# **ALERT SERVICE BULLETIN**

ENGINE — BLADE ASSEMBLY, 1ST STAGE, LOW PRESSURE COMPRESSOR (LPC) — ULTRASONIC TESTING (UT) INSPECTION AND THERMAL ACOUSTIC IMAGE (TAI) INSPECTION OF 1ST STAGE LPC BLADE ASSEMBLIES TO FIND AIRFOIL CRACKS

MODEL APPLICATION PW4074, PW4074D, PW4077, PW4077D, PW4084D, PW4090, PW4090-3

PW4G-112-A72-361

LOCATION OF THE LPC FAN BLADES 72-31-00 FIGURE 1

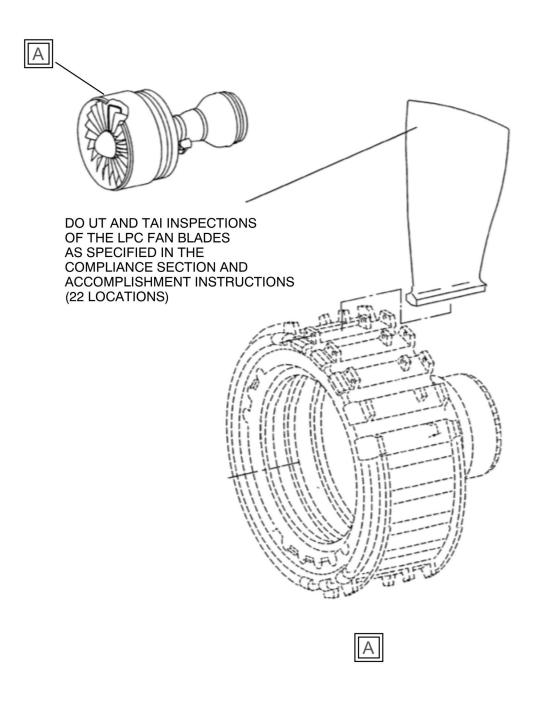
1. For engines installed on aircraft that require UT inspection in accordance with the intervals in this Alert Service Bulletin, remove necessary hardware for access to accomplish UT inspection as follows:

A. Remove the LPC fan blades as specified in Reference 6, Boeing 777 Aircraft Maintenance Manual, Chapter/Section 72-31-02.

- A. Remove the fan blade fairings as specified in Reference 6, Boeing 777 Aircraft Maintenance Manual, Chapter/Section 72-31-07.
- 2. The removal of LPC Fan Blades, PN 52A241, PN 55A901, PN 55A901-001, PN 55A801, PN 55A801-001, PN 56A201, PN 56A201-001, and PN 56A221, for UT and/or TAI inspection is dictated by the initial inspection requirements and/or repetitive inspection intervals in this Alert Service Bulletin. When removal of LPC fan blades is dictated by these intervals, do as follows:
  - A. Remove the LPC fan blades as specified in Reference 6, Boeing 777 Aircraft Maintenance Manual, Chapter/Section 72-31-02.

A. Remove the LPC fan blades as specified in Reference 4 or 5, EM, Chapter/Section 72-00-31, Removal-03.

- A. Remove the fan blade fairings as specified in Reference 4 or 5, EM, Chapter/Section 72-00-31, Removal-03.
- 2. The removal of LPC Fan Blades, PN 52A241, PN 55A901, PN 55A901-001, PN 55A801, PN 55A801-001, PN 56A201, PN 56A201-001, and PN 56A221, for UT and/or TAI inspection is dictated by the initial inspection requirements and/or repetitive inspection intervals in this Alert Service Bulletin. When removal of LPC fan blades is dictated by these intervals, do as follows:

- A. Remove the LPC fan blades as specified in Reference 4 or 5, EM, Chapter/Section 72-00-31, Removal-03.
  - B. Return the LPC fan blades for TAI inspection to the approved source listed in the Vendor Services Section.

- 3. If necessary, replace the removed LPC fan blades as specified in Reference 4 or 5, EM, Chapter/Section 72-00-31, Installation-03.
- 4. If necessary, replace the removed fan blade fairings as specified in Reference 4 or 5, EM, Chapter/Section 72-00-31, Installation-03.
